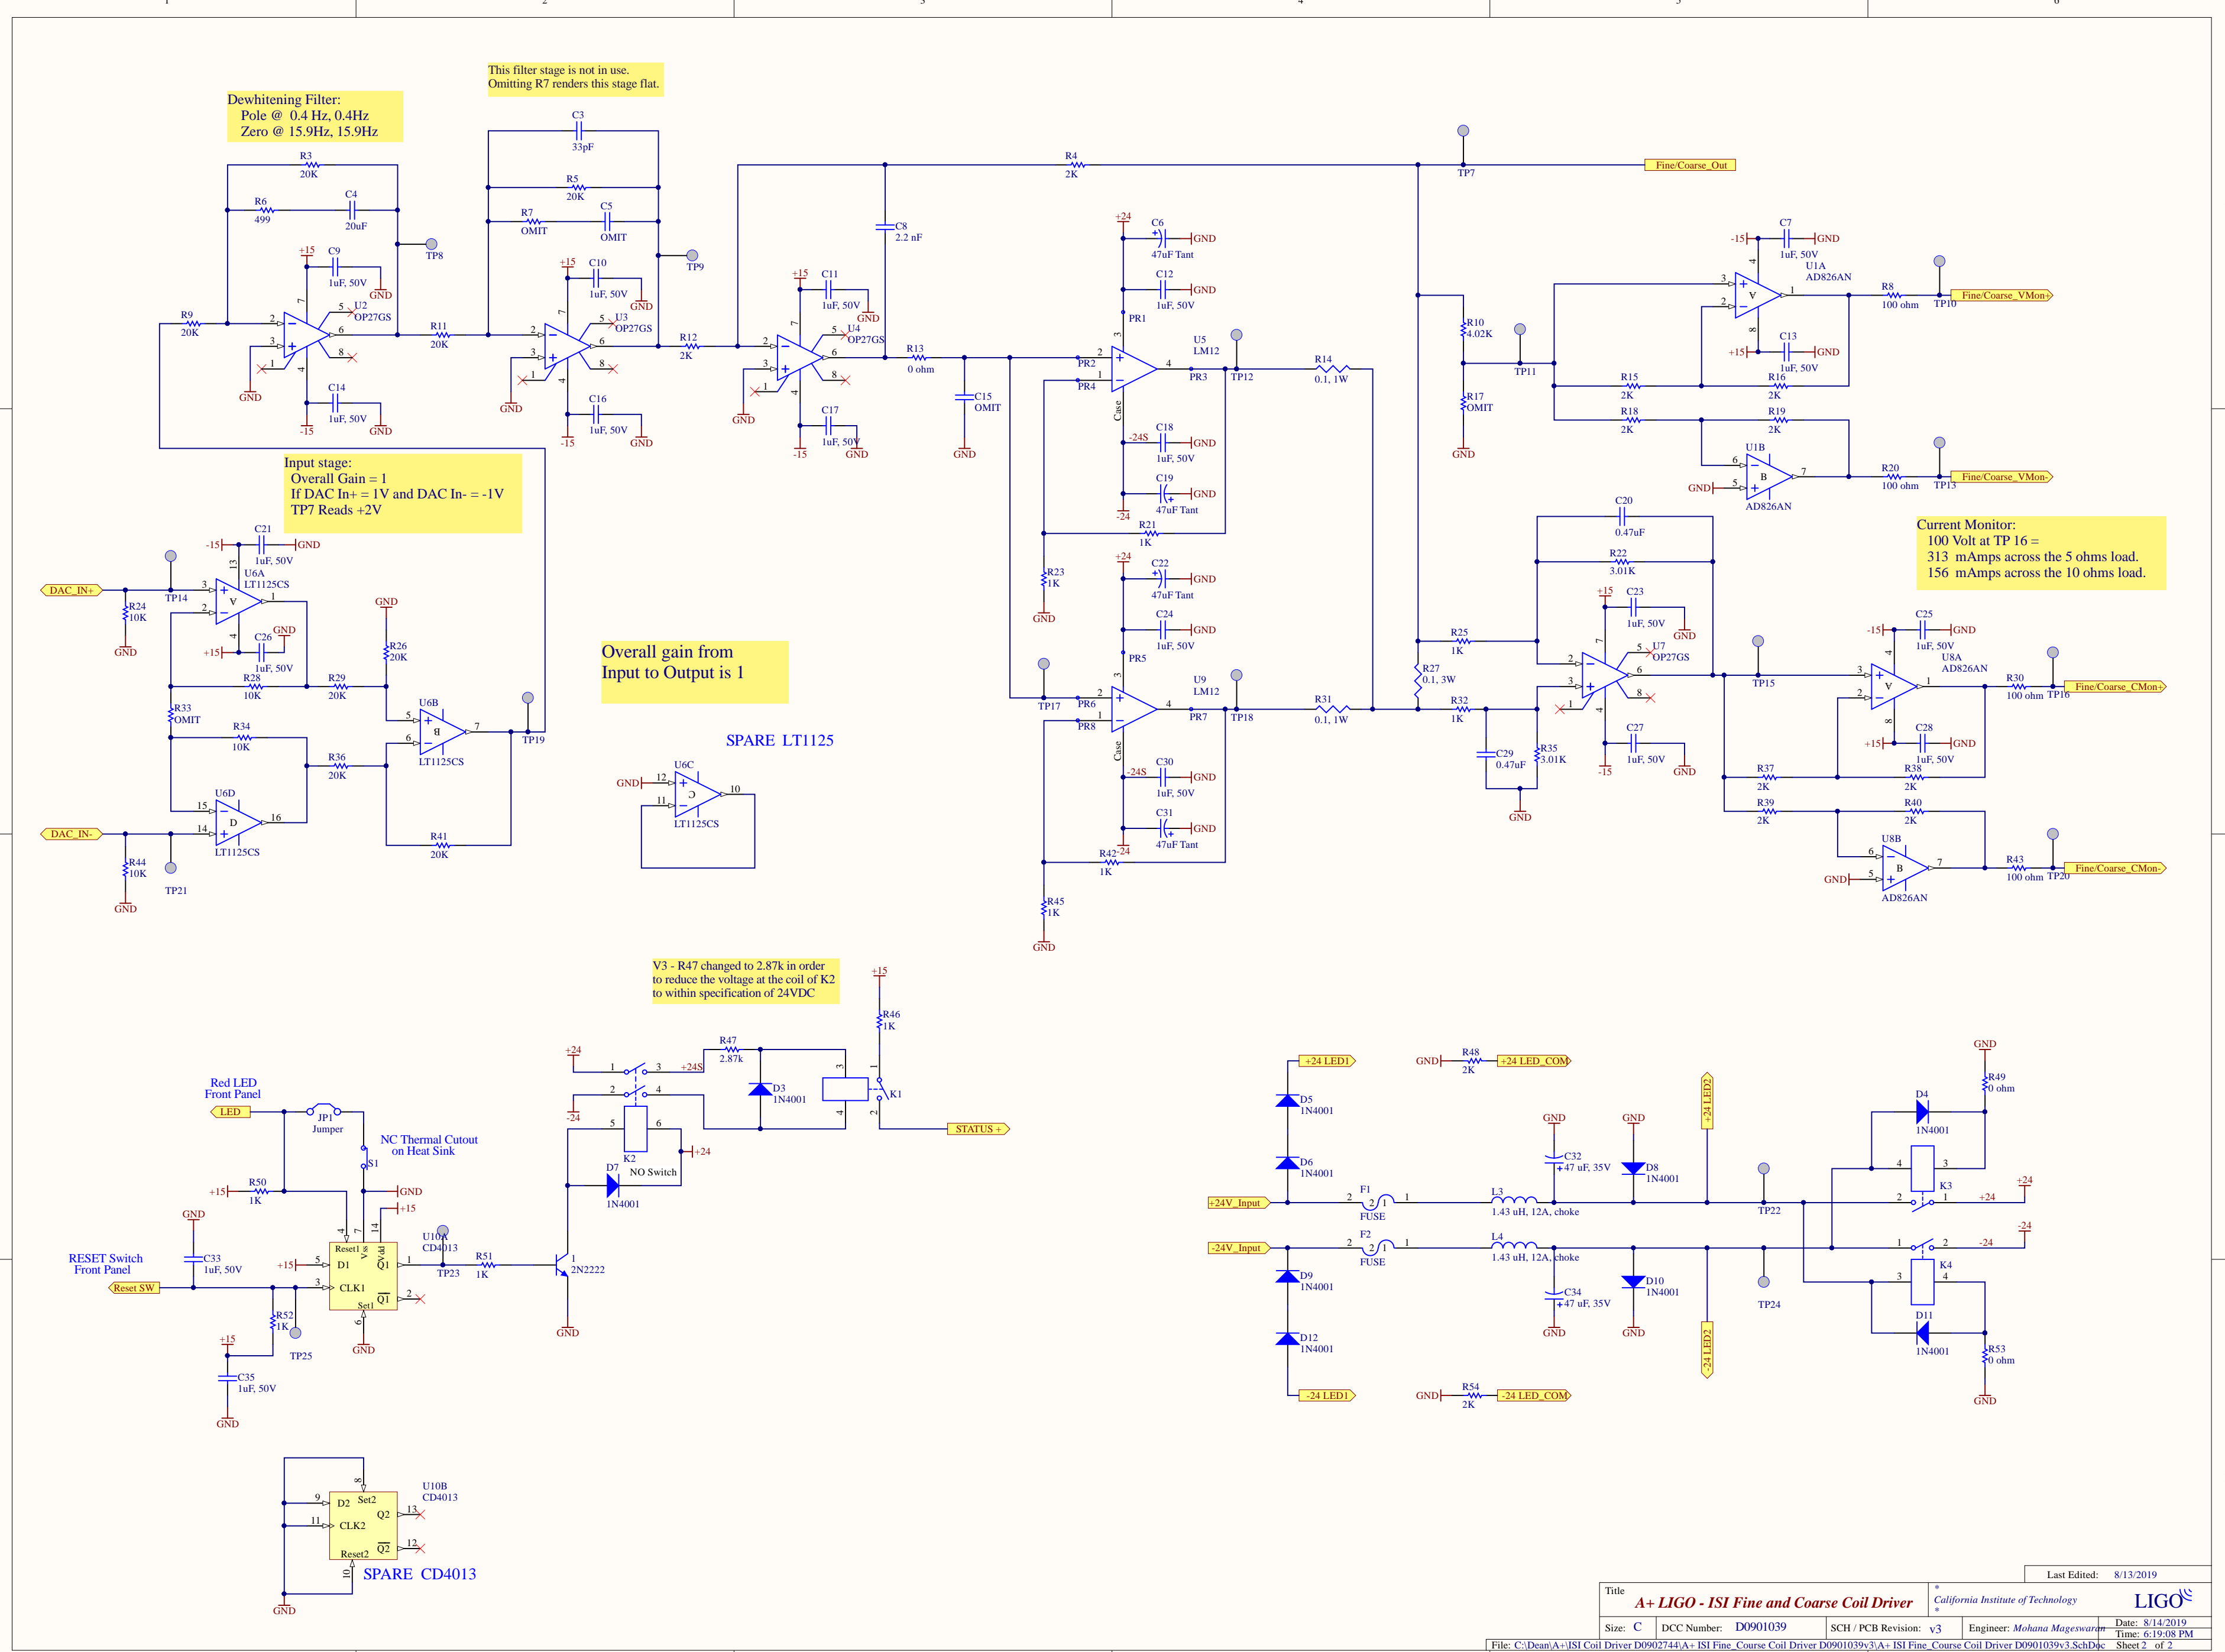
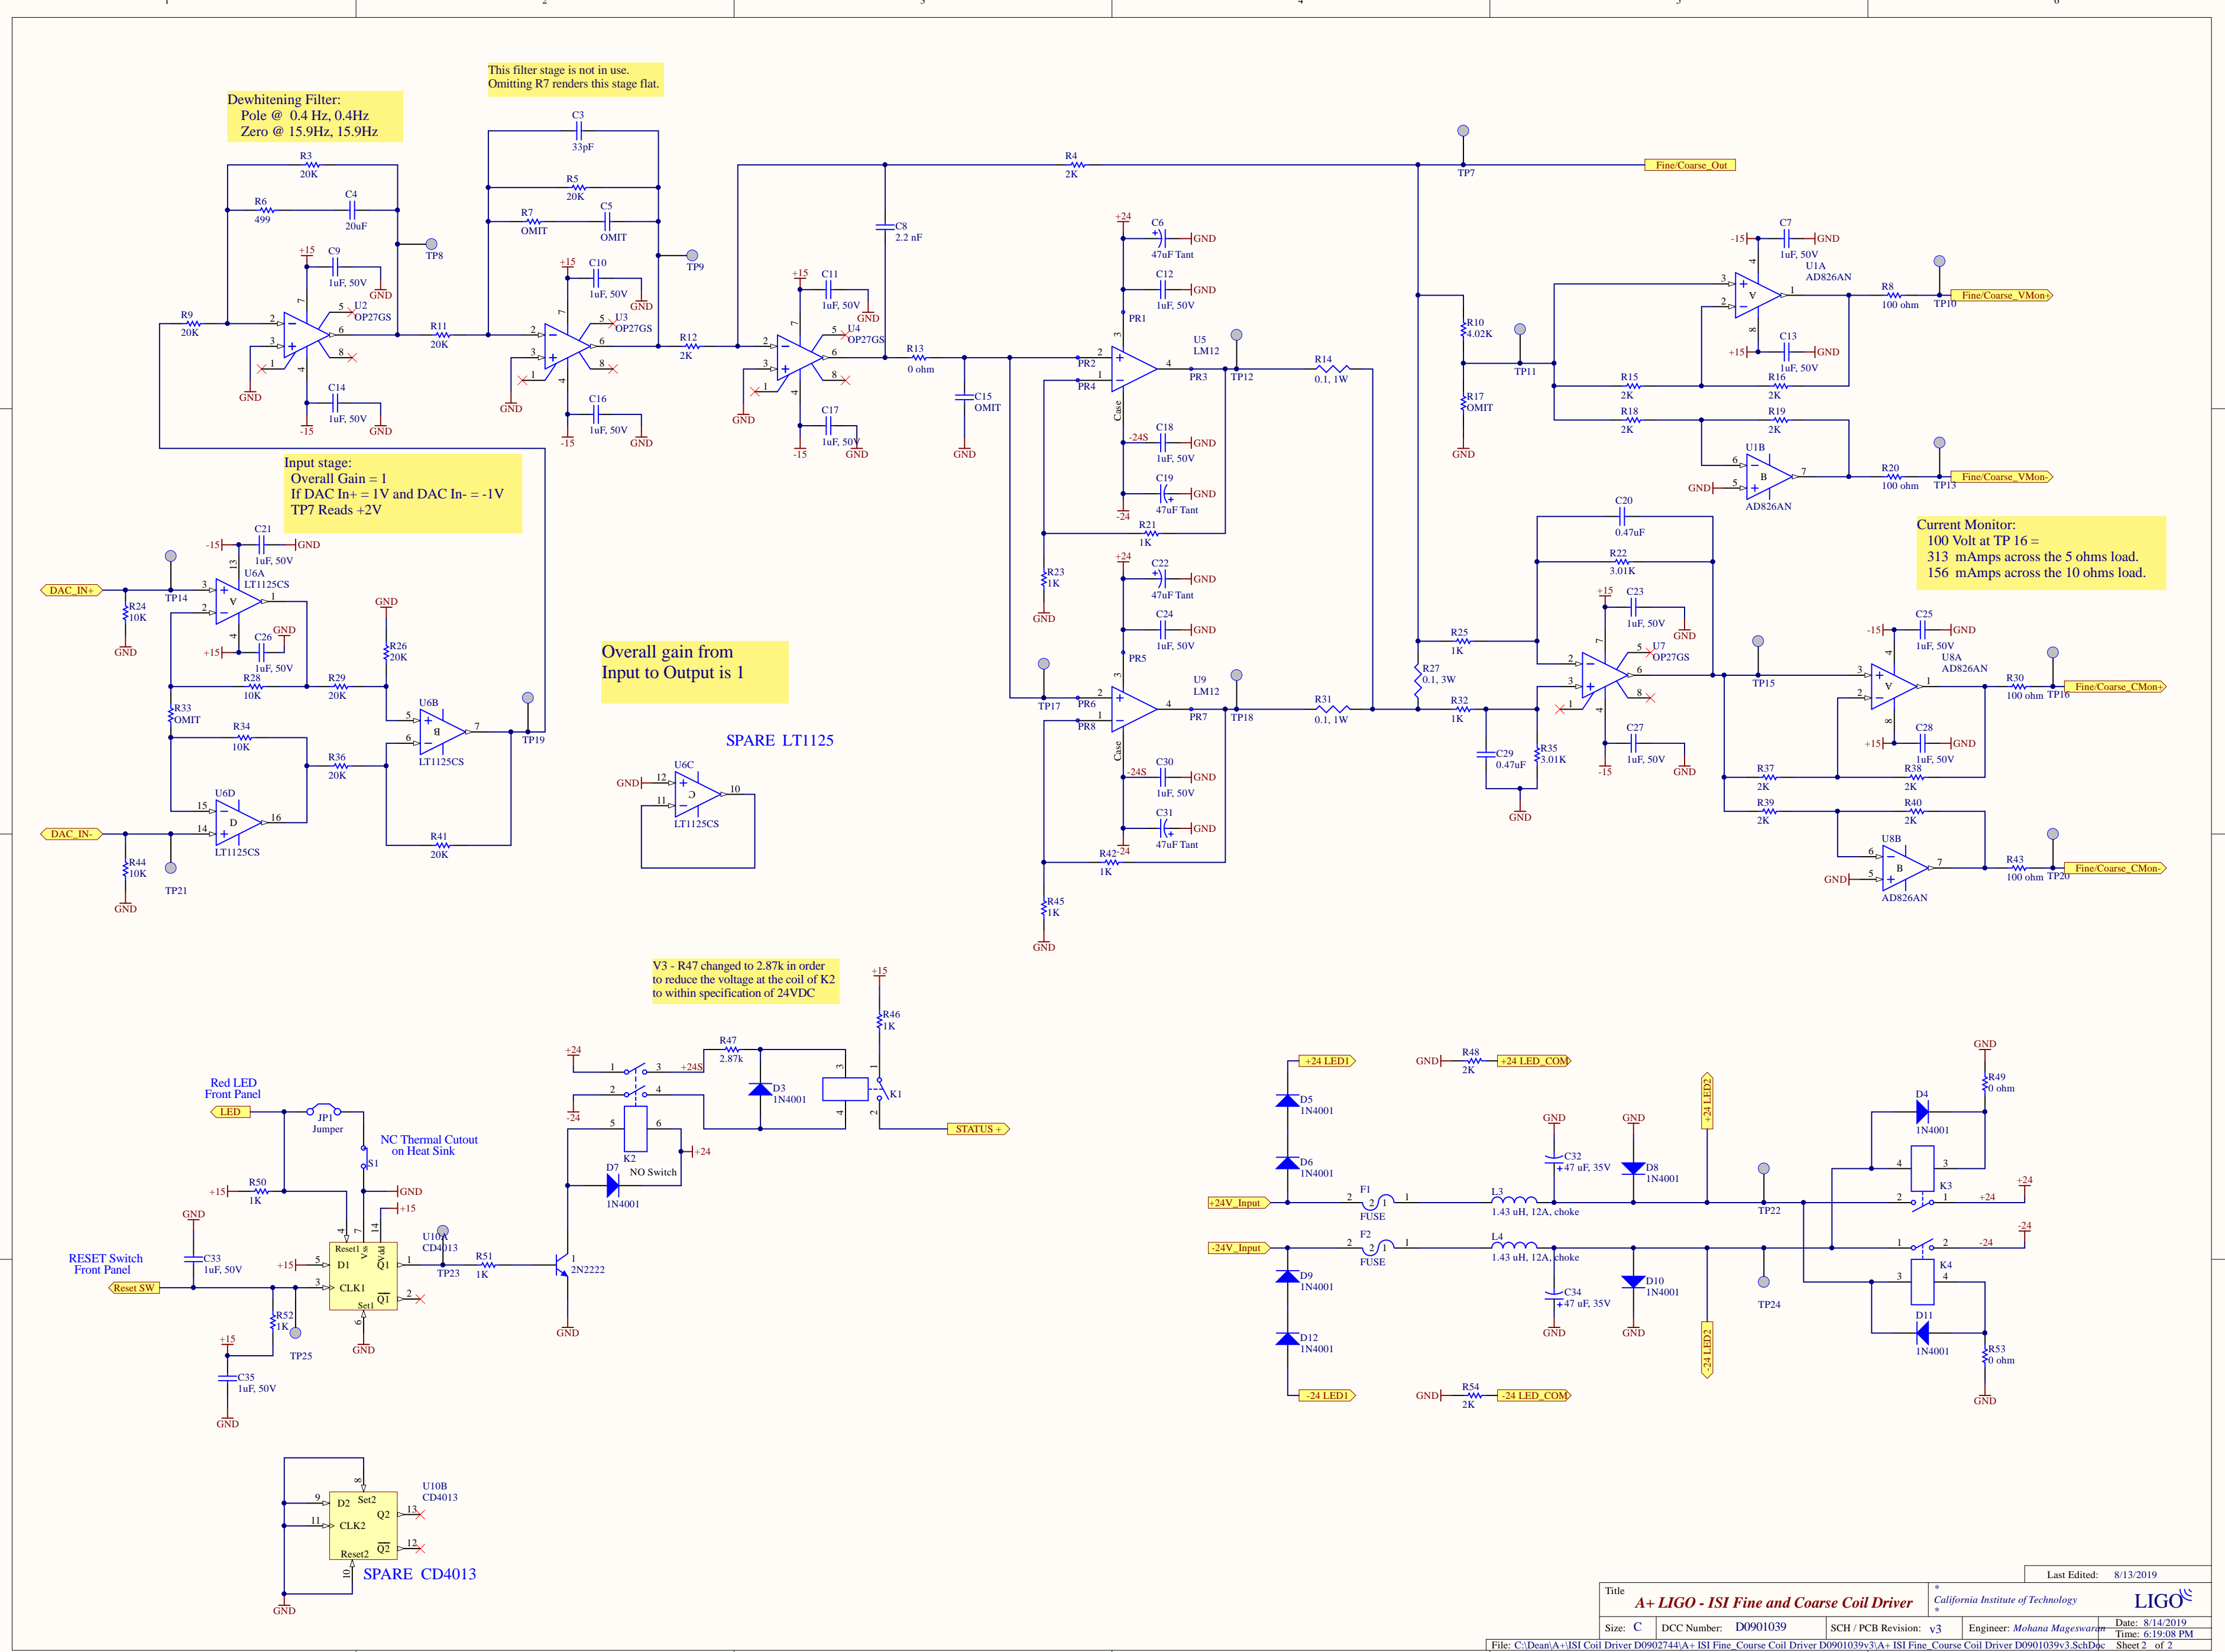
V3 - R47 changed to 2.87k in order
to reduce the voltage at the coil of K2
to within specification of 24VDC
